Application by RiverOak Strategic Partners to upgrade and reopen Manston Airport Comments following Issue Specific Hearings for Deadline 8 submission

Manston Airport DCO Application: Review of Further Noise Documentation June 2019

Report for Thanet District Council, 14th June 2019

The figure below is part of the applicant response for request 7.

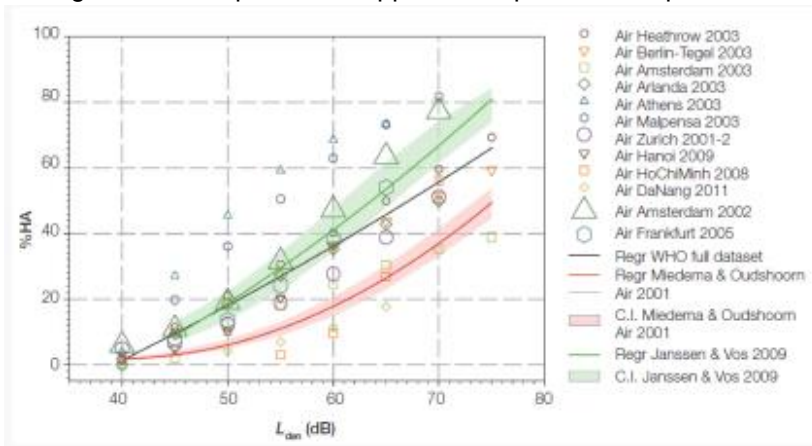
Request	Applicant response up to deadline 5	Assessment of applicant response	Recommendation (of 2 nd May 2019)	Assessment of applicant response at deadline 7a	Current recommendation
	<p>regression analysis of the data in all studies to generate an ERF. This is shown as a black line in the figure.</p> <p><i>[Note: see figure provided beneath this Table 2.1.]</i></p> <p>It is important to note that WHO’s most recent guidance provides guidance on the onset of effects. It does not define limit values, nor does it set “effect levels” (LOAEL, SOAEL UAEL etc). The WHO Environmental Guidelines for the European Region (2018) state that “data and exposure–response curves derived in a local context should be applied whenever possible to assess the specific relationship between noise and annoyance in a given situation”. This is acknowledged by Government in their</p>

Figure 2.1 LAeq,8hr Contours From Ecological Chapter

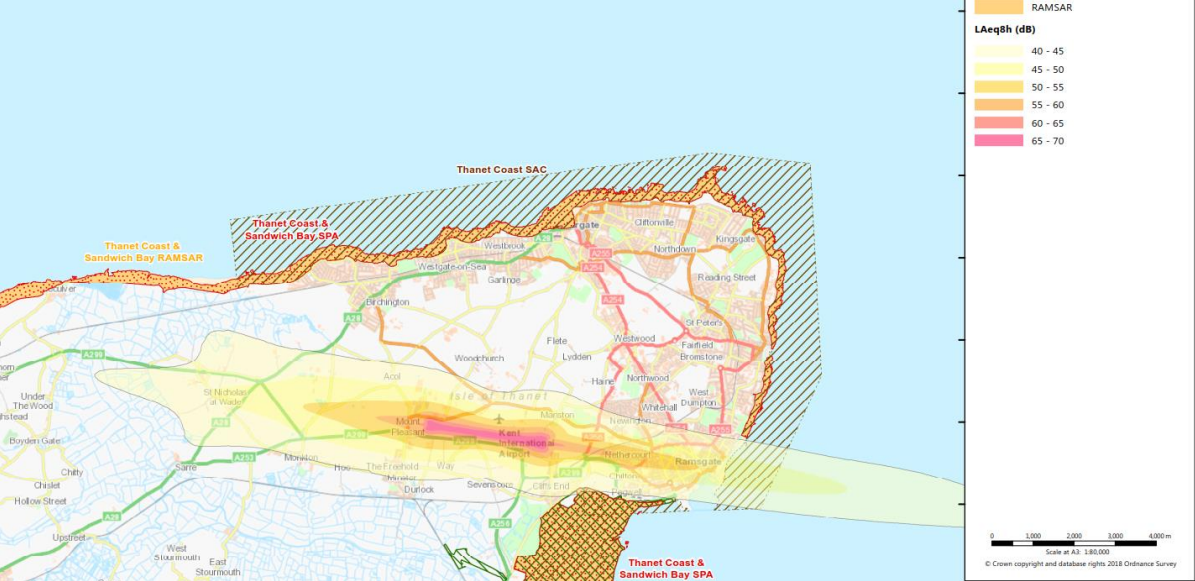
The figure below is figure 2.1 and is part of the assessment of applicant response for request 5:
